EMERGENCY PLAN IMPLEMENTING PROCEDURE

FLORIDA POWER CORPORATION

CRYSTAL RIVER UNIT 3

DUTIES OF THE TECHNICAL SUPPORT CENTER ACCIDENT ASSESSMENT TEAM

FIGURE 1

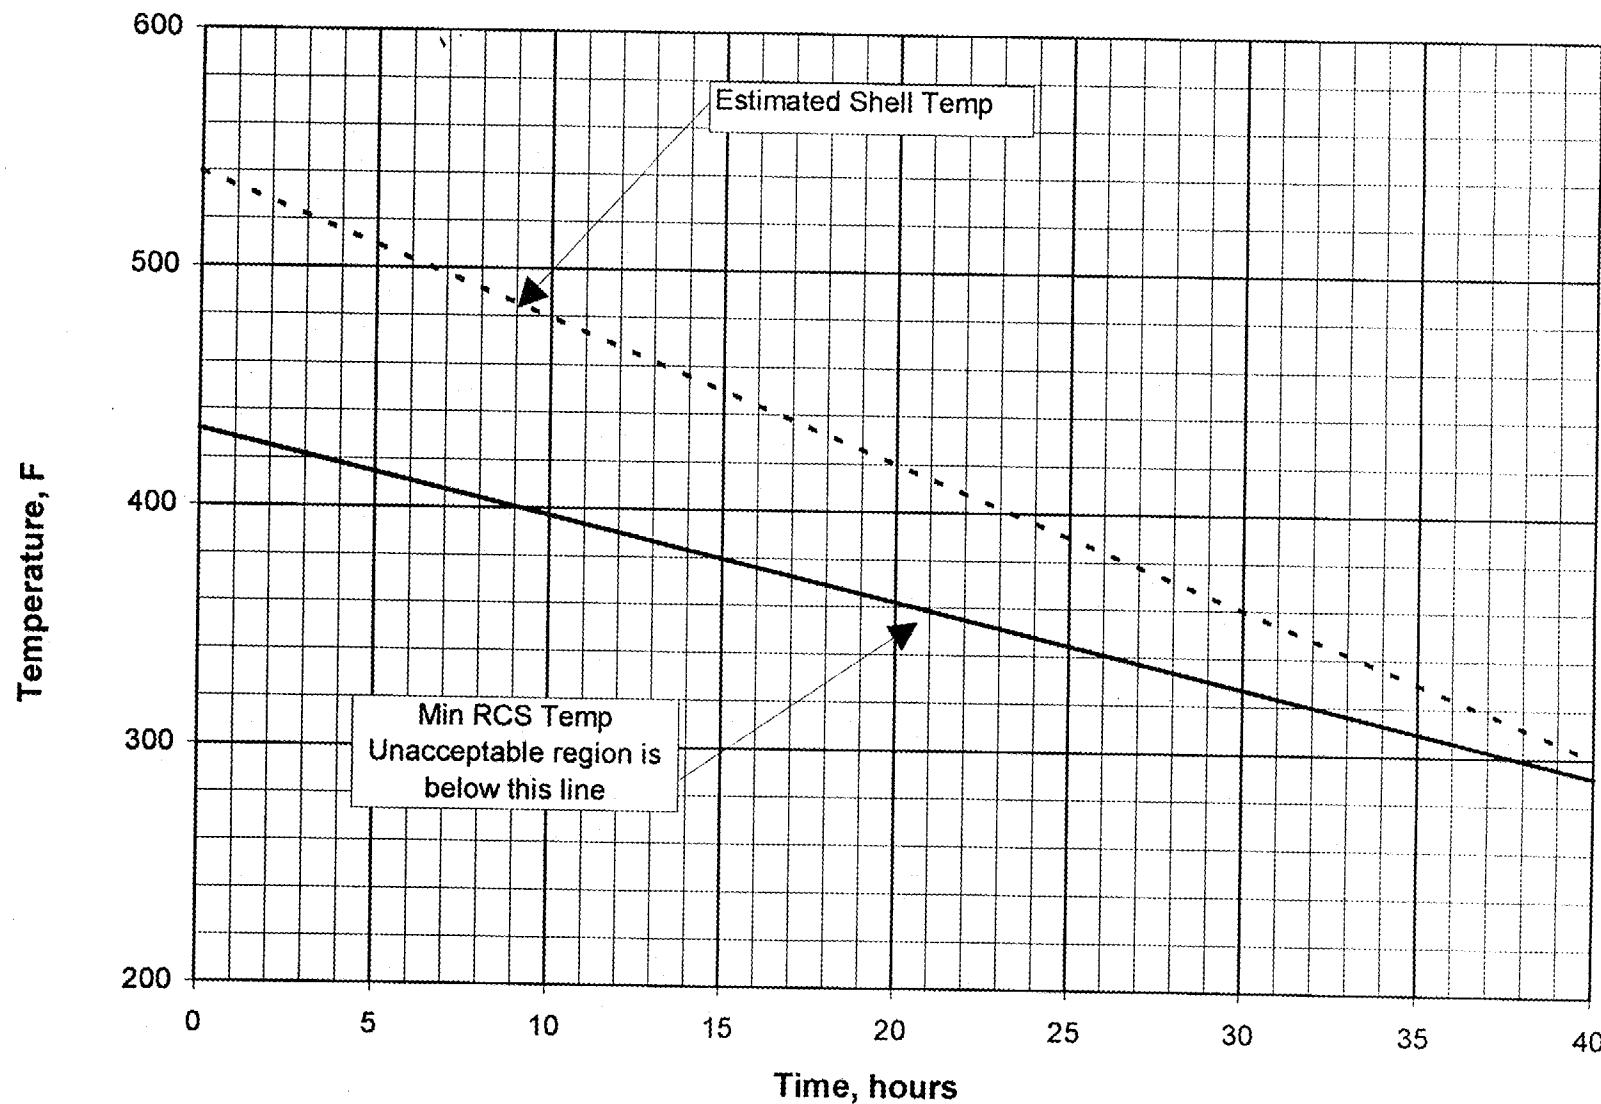
- 4.2.4    Maintain Tincore above the "Min RCS Temp" curve shown in Figure 1 to prevent challenging the tensile limit of the tubes.  
IF RCS temperature approaches the "Min RCS Temp" limit,  
THEN stop or minimize the cooldown. This minimum temperature limit is only applicable when any RCP is operating.

4.1.3                   Added new step to adjust cooldown rate to control tube to shell delta T limits (NUPOST 51811). Renumbered subsequent steps.
